**CITY OF SAINT PAUL
HERITAGE PRESERVATION COMMISSION STAFF REPORT**

FILE NAME: 955 Summit Avenue
DATE OF APPLICATION: 4-2-15 and 4-14-15
APPLICANT: Jerry Quicksell, Quicksell Brothers Builders
OWNER: Shari and Roger Wilsey
DATE OF HEARING: April 23, 2015
HPC SITE/DISTRICT: Hill Heritage Preservation District
CATEGORY: Pivotal
CLASSIFICATION: Building Permit
STAFF INVESTIGATION AND REPORT: Amy Spong
DATE: April 14, 2015

3 EXISTING REAR (NORTH) ELEVATION
 1/8" = 1'-0"
 OUTLINE OF NEW ADDITION CONNECTION TO EXISTING HOUSE (KITCHEN).
 OUTLINE OF NEW ADDITION (FAMILY ROOM).

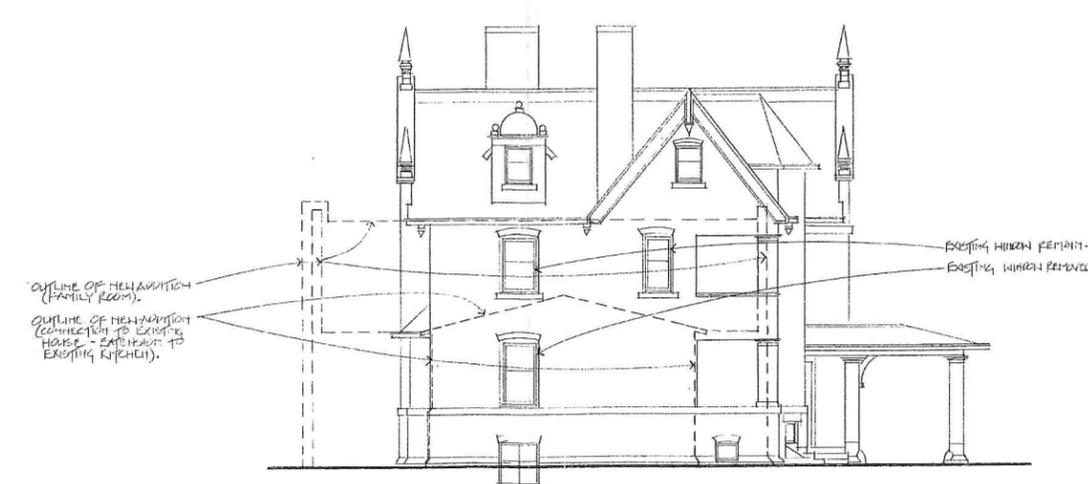
The applicant is proposing to construct an addition to the rear of the house, but it will project 12 feet beyond the east elevation. Sheet 4 of the drawings indicates what exterior wall portions will be demolished to connect the new addition to the main house. A low sloping gabled roof will intersect with a more steeply pitched (12/12) gable roof with parapet walls. The addition will be used as a one-story however; the volume of the space is more like a two-story space. The footprint of the addition will increase the footprint of the main house by about 50% and the ridge of the addition is at the height of the eave of the main house. The proposed addition measures approximately 33 feet by 46 feet by 25 feet tall.

4. **(74.64 (a)(2))**. The proposal *will not result in loss of distinguishing original qualities or character of the building*. There will be some impact to the site and environment given the proposed size and volume of the addition. *The removal or alteration of a large portion of the rear elevation and a window avoids removal of distinctive architectural features*. The rear original corner porch remains intact.
